Access Compliance Report

Public Rights-of-Way

Intersection ID: 54371	Main Street: BENSEVAL_LN	Cross Street: LONGWALL_LN	Location: E
ADA ID: 62A870FCD341	Ramp Type: BlendTrans1	Initial Pass/Fail: Fail	Overall Compliance: No
		Severity Score: 8.75

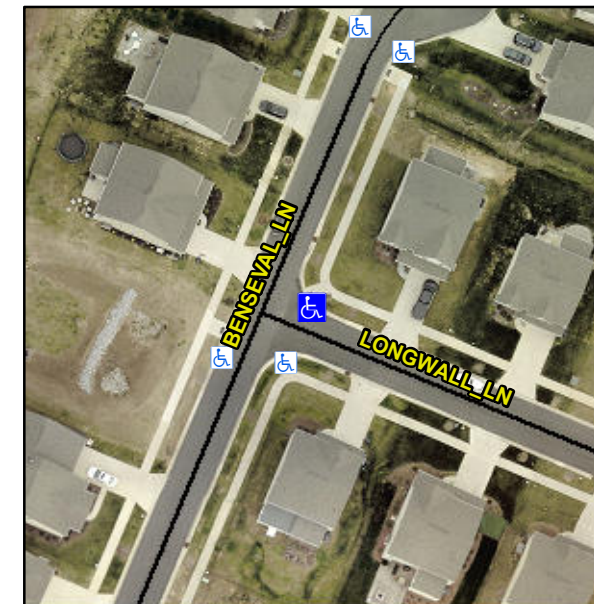
Not Found, R304.5.1

Compliance	Description	Data	Compliance	Description	Data
N/A	Ramp Length (in)	97.0	Yes	BlendTrans Slope (%)	4.1
No	Ramp Width (in)	47.5	Yes	BlendTrans XSlope (%)	1.7
N/A	Flare Type LT	N/A	N/A	Flare Type RT	N/A
N/A	Flare Slope LT (%)	N/A	N/A	Flare Slope RT (%)	N/A
N/A	Flare Traversable LT?	N/A	N/A	Flare Traversable RT?	N/A
N/A	Landing Length (in)	N/A	N/A	DWS Provided?	N/A
N/A	Landing Width (in)	N/A	N/A	DWS Contrast?	N/A
N/A	Landing Slope (%)	N/A	N/A	DWS Length (in)	N/A
N/A	Landing X Slope (%)	N/A	N/A	DWS Full Width?	N/A
N/A	Landing Curb? (Y/N)	N/A	N/A	DWS Offset (in)	N/A
N/A	Shared Landing?	N/A			
N/A	Gutter Ponding?	N/A	N/A	Gutter Slope (%)	N/A
N/A	Gutter Lip Ht (in)	N/A	N/A	Gutter X Slope (%)	N/A
N/A	Painted X Walk1?	No	N/A	Painted X Walk2?	No
	X Walk 1 Direction	To NW		X Walk 2 Direction	To SW
	X Walk 1 Width (in)	N/A		X Walk 2 Width (in)	N/A
	X Walk 1 Slope (%)	1.5		X Walk 2 Slope (%)	0.4
	X Walk 1 X Slope (%)	1.8		X Walk 2 X Slope (%)	4.8

N/A	Ramp inside XWalk1?	N/A	N/A	Ramp inside XWalk2?	N/A
	Road Slope (%)	4.3		Clear Space?	N/A
	Road X Slope (%)	1.1	N/A	Clear Space to XWalk (in)	N/A
N/A	Any Obstructions?	N/A	N/A	Storm Grate/Utility Hazard?	N/A
	Obstruction Type			Storm Grate/Utility Type	
		N/A			N/A
			Yes	Surface Condition? (G/P)	Good
			No	Curb Slope (%)	17.2

Remove & Replace Curb Ramp With Two New Directional Ramps or Equivalent.
